**Village of Royal Palm Beach**  
**Village Council**  
**Agenda Item Summary**

**PUBLIC HEARING TO CONSIDER LANDSCAPE WAIVER APPLICATION NO. 20-115 (LW) AND APPROVAL OF ORDER LW-22-02, AN APPLICATION BY D.R. HORTON, INC. FOR CONSIDERATION OF THREE (3) LANDSCAPE WAIVERS AS FOLLOWS: (1) WAIVER FROM SEC. 15-131 (D) TO ALLOW FOR A ZERO (0) FOOT BUFFER ALONG THE ENTRANCE DRIVE WHERE VILLAGE CODE REQUIRES 25 FEET; (2) WAIVER FROM SEC. 15-131 (E) TO ALLOW FOR A FIVE (5) FOOT BUFFER ALONG THE WESTERN PROPERTY LINE WHERE VILLAGE CODE REQUIRES 15 FEET; AND (3) WAIVER FROM SEC. 15-131 (B) TO ALLOW FOR NO BERMS WITHIN THE BUFFERS WHERE VILLAGE CODE REQUIRES A 3-FOOT BERM, FOR A PROPERTY LOCATED NORTHWEST OF THE OKEECHOBEE BOULEVARD AND ROYAL PALM BEACH BOULEVARD INTERSECTION.**

**CASE NO. LW-22-02**

Directly below is an illustration of the Site Plan showing the locations of the Waiver requests. Please refer to the Waiver Chart below for the waiver symbols. The zoom feature will aid in the review of this document.

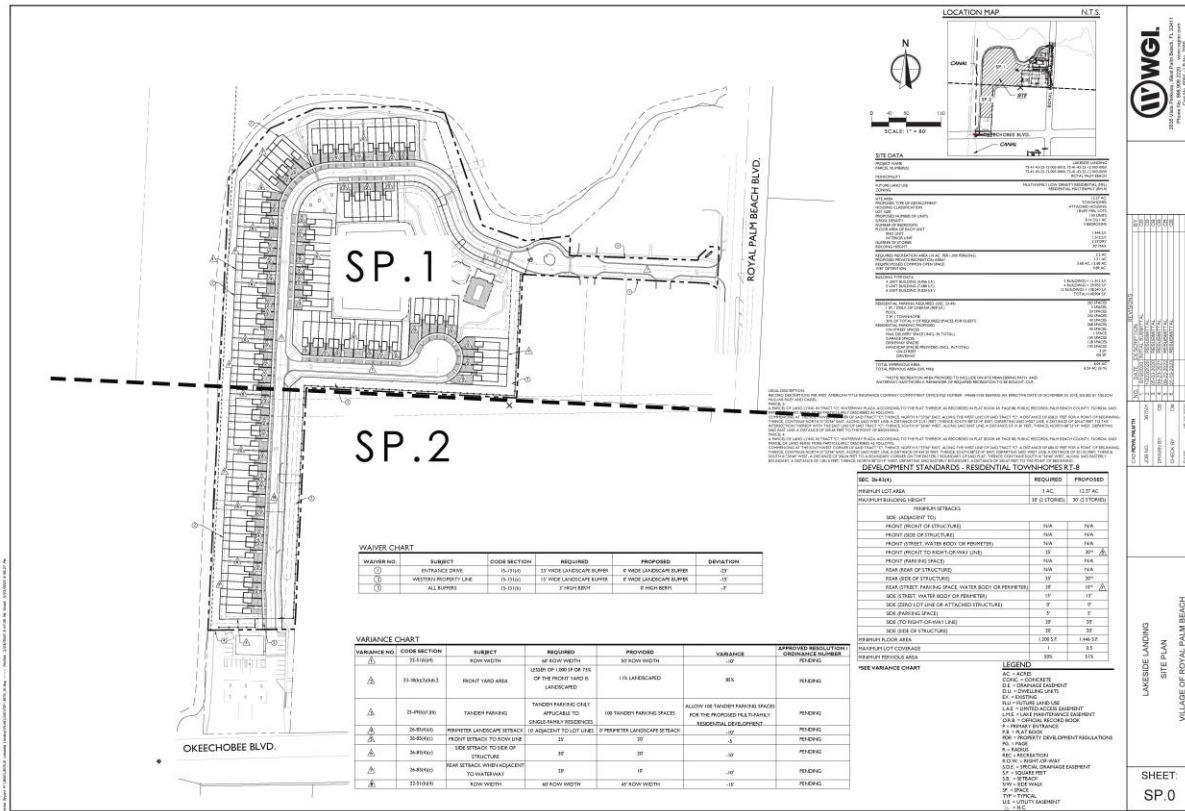
Sec. 15-131 (d): This Waiver request is to allow for a zero (0) foot buffer along the entrance drive where Village Code requires 25 feet. This Waiver request is represented in **Attachment A** with a circle with a "1" inside.

Section 15-131 (e): This Waiver request is to allow for a five (5) foot buffer along the western property line adjacent to the canal system, where Village Code requires a 15 foot buffer. This Waiver request is represented in **Attachment A** with a circle with a "2" inside.

Sec. 15-131 (b): This Waiver request is to allow for no berms within the buffers where Village Code requires a 3-foot berm. This Waiver request is represented in **Attachment A** with a circle with a "3" inside.

Staff Recommendation: Staff is recommending Approval of the requested Landscape Waiver #1 and generally concurs with the Applicant's assessment. Staff believes that this is the minimum waiver necessary to allow reasonable use of the property.

Staff Recommendation: Staff is recommending Approval of the requested Landscape Waiver #2 and generally concurs with the Applicant's assessment. Staff believes that this is the minimum waiver necessary to allow reasonable use of the property.

Staff Recommendation: Staff is recommending Approval of the requested Landscape Waiver #3 and generally concurs with the Applicant's assessment. Staff believes that this is the minimum waiver necessary to allow reasonable use of the property.
